Subject: AP1000 Response to Request for Additional Information (TR 85)

Response to Request for Additional Information on Technical Report No. 85

RAI Response Number: RAI-TR85-SEB1-15

RAI Response Number: RAI-TR85-SEB1-17

Figure RAI-TR85-SEB1-15-1
Bearing pressures in linear analysis due to containment design pressure

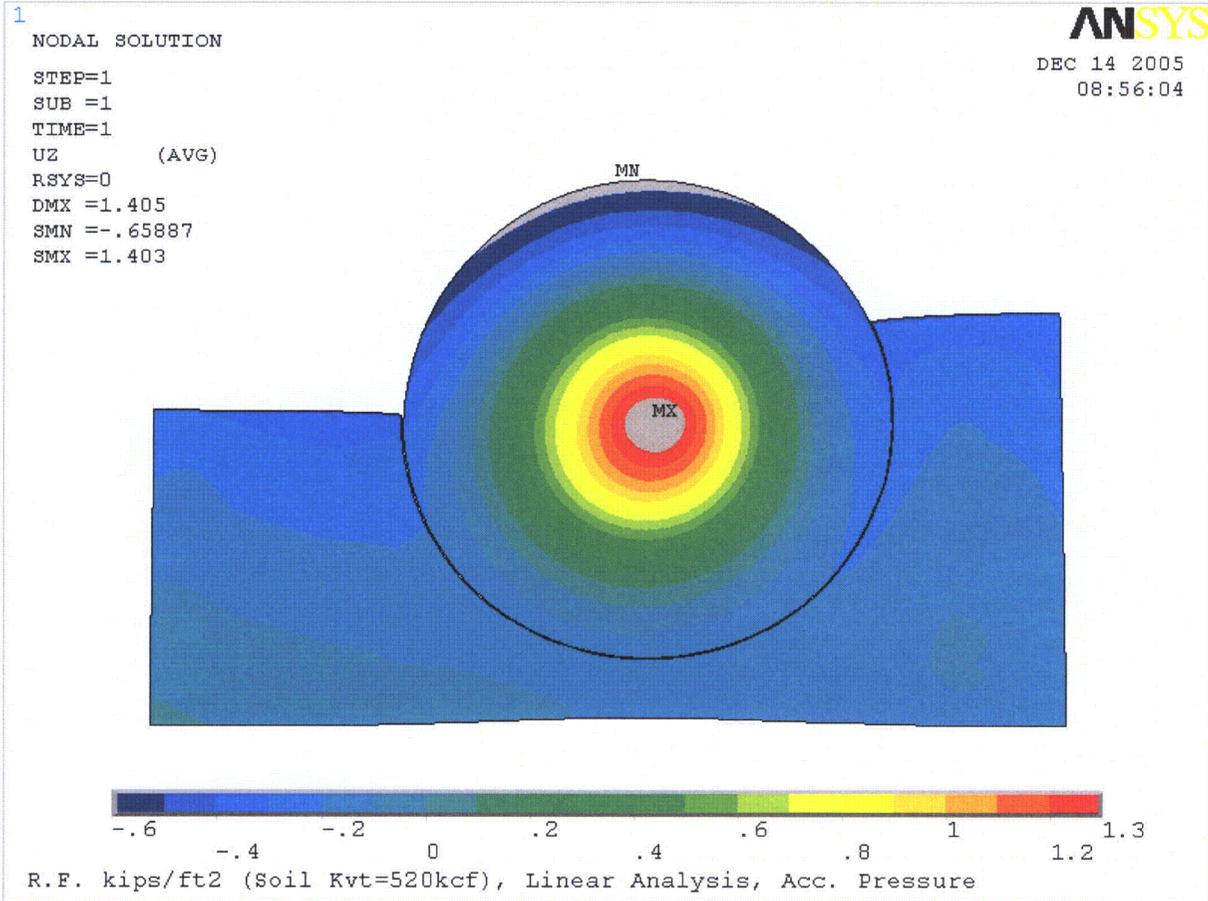
In the response for item d of the RAI, Westinghouse indicated that another non-linear analysis was performed with the containment pressure loading. The results showed that the containment pressure had only a small effect on the bearing pressures. The RAI response also indicated that the accidental thermal loading does not occur concurrent with the design pressure and is not included as a design case. Westinghouse is requested to avoid using qualitative terms such as small effect without quantify how small the contribution is. Therefore, quantify the magnitude of the soil bearing pressure contribution from design pressure and accidental pressure, and explain why they are not included in determining the maximum soil bearing pressure demand, unless it is truly a negligible value. In addition, although the RAI response states that the accidental thermal loading does not occur concurrent with the design pressure, accidental thermal loading can occur with accidental pressure, along with the SSE and normal loads. Explain why this loading case was not considered.

Figure RAI-TR85-SEB1-15-1 shows the soil bearing pressures from a linear analysis of the nuclear island basemat due to containment design pressure. This design pressure exceeds the accident pressure. The containment pressure is applied in the finite element model at the bottom head and a corresponding uplift is applied at the cylindrical shell. The total vertical reaction is zero. The bearing pressures are compressive at the center of the bottom head and tensile at the edge. The maximum bearing pressure of 1.4 ksf is below the center of the containment. The containment design pressure was included in two of the (1.0, 0.4, 0.4) seismic load combinations to confirm that its inclusion did not significantly affect the non-linear response. When the containment pressure was included in the non-linear lift off analyses

together with dead load and the equivalent static seismic loads, this study showed a small reduction in the bearing compressive pressure at the edge of the model from that when analyzed without containment pressure. Since the maximum bearing pressures are at the west edge of the nuclear island, the maximum bearing pressure reduces slightly when the containment is pressurized. The nuclear island basemat is designed for load cases both with and without containment pressure.

The design basis accident results in pressures and atmospheric temperatures inside containment. The safety systems are designed such that the accident pressure reduces below one half of the design pressure within 24 hours. Due to the large thickness of the containment internal concrete basemat and of the nuclear island basemat, thermal conditions are slow to develop across the basemat and are not concurrent with the containment design pressure. In addition, the SSE and design basis accident are independent events that are conservatively assumed to be concurrent based on past precedent. Accident thermal conditions are therefore not considered concurrent with the design pressure and the SSE.
